Re: 1003 Mt. Zion Marlboro Road, Lothian

T.A. 8000-9007-9813

1003 Mount Zion Marlboro Road Lothian

2024-0096-P

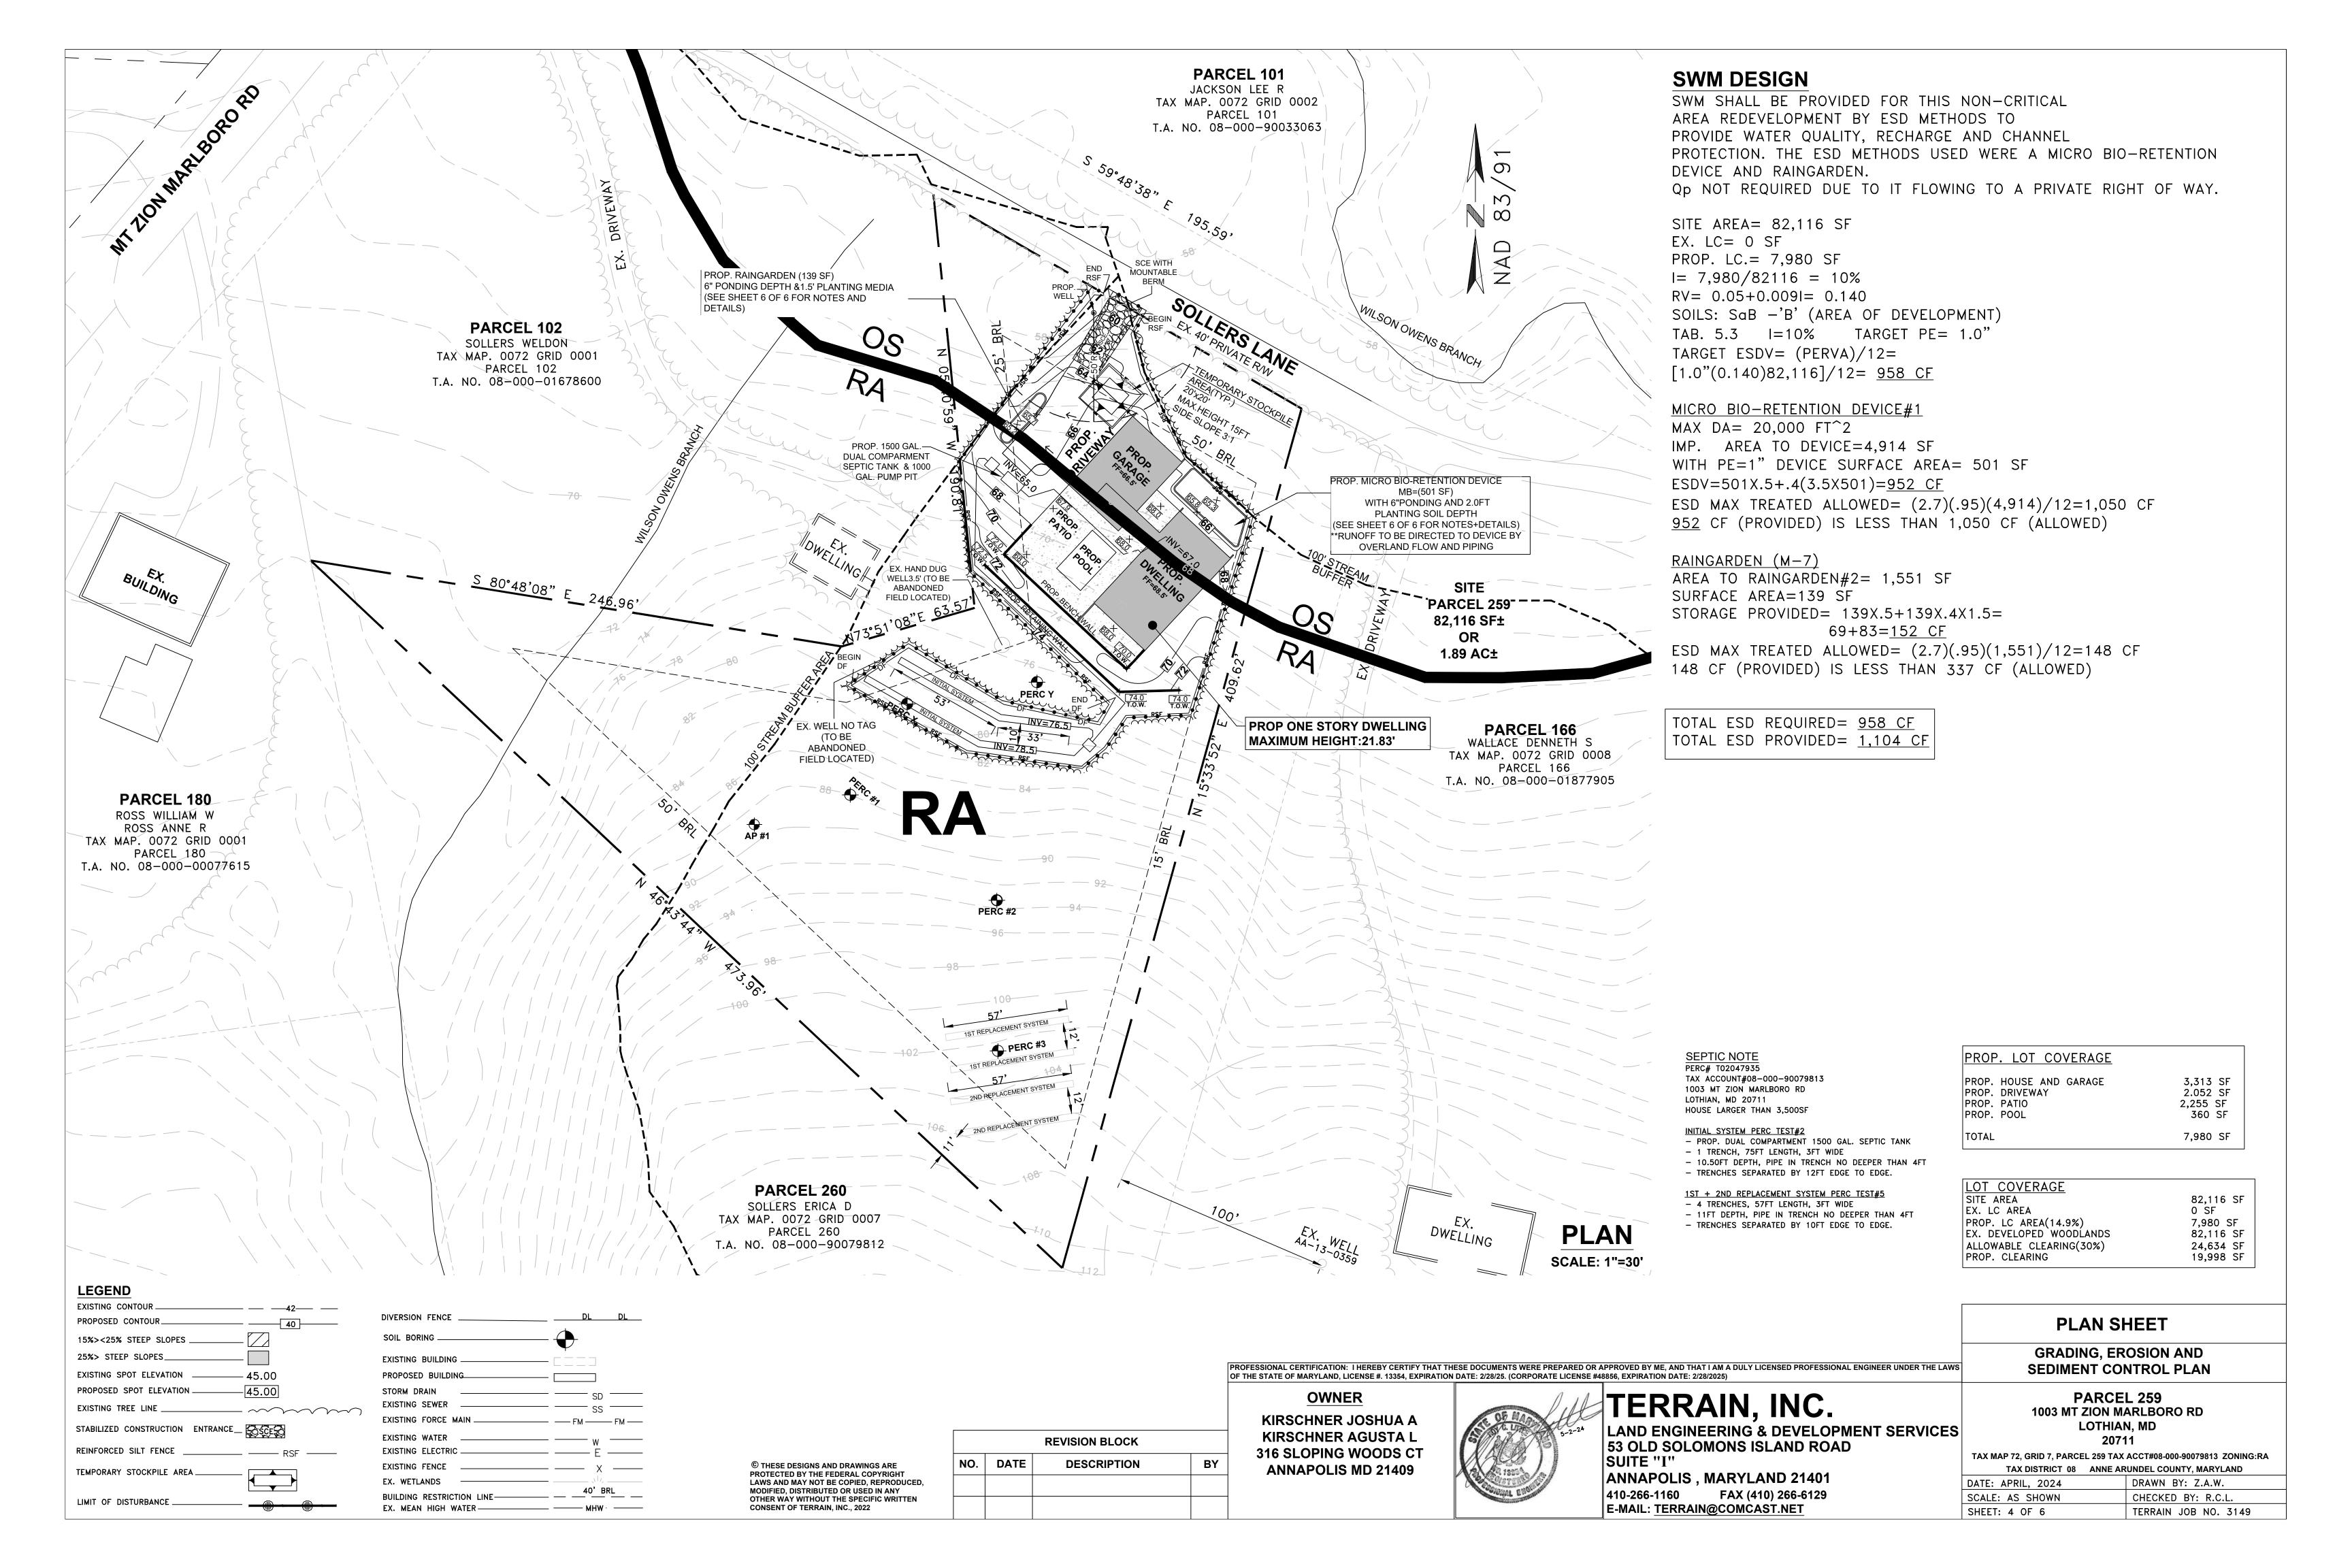
The site plan must clearly label the height and number of stories of the proposed dwelling. The OS label shown on the site plan covers some of the proposed development area and should be relocated for clarity. The applicant should explore ways to minimize the proposal as it does not appear to represent the minimum necessary. The development contains a large garage, patio and pool. It appears that the development could be reconfigured into a smaller area and the pool could be eliminated as pools are generally not considered necessary for the use and enjoyment of a residential lot. The applicant will need to provide adequate justification on how the proposal meets the variance standards contained in 18-16-305.

2. All stormwater conveyance systems shall be designed so that no building or habitable structure, either proposed or existing, is flooded or has water impounded against it during the 100-year storm event.

3. Per 6.1.4 (G) of the County Stormwater Practices and Procedures manual, SWM facilities shall not be located in areas that are off-limits to development, e.g., natural resource areas and their steep slopes and buffers.

4. Ensure the proposed improvement including runoff, seepage, and slope saturation does not adversely impact the integrity of the slope and potential impact of slope failure.

6. The soil boring results, including the seasonal high groundwater elevation, need to be added to the plan. The calculations will not be reviewed until the siting and suitability are first confirmed to be adequate.

Response: The dwelling labels have been added to the plan. This will be a one-story building with a ridge height of 21.83'. The plan has been revised for clarity. It is our belief that the house design and layout is minimum necessary as it is a modest sized house that is less than half of the maximum lot coverage and under the allowable clearing limitations.

Response: The SWM facilities are downstream from the proposed structure. The 100-year storm will safely be conveyed away from the proposed structure to the existing stream located north of the property.

Response: The proposed SWM facilities are located outside of the environmentally protected areas.

Response The proposed improvements will have a safe conveyance for the discharge. There will be no impact to the integrity of the slope.

Response: The soil boring shown on the Grading Permit Submittal verifies that high ground water will not impact the adequacy of the SWM facility.
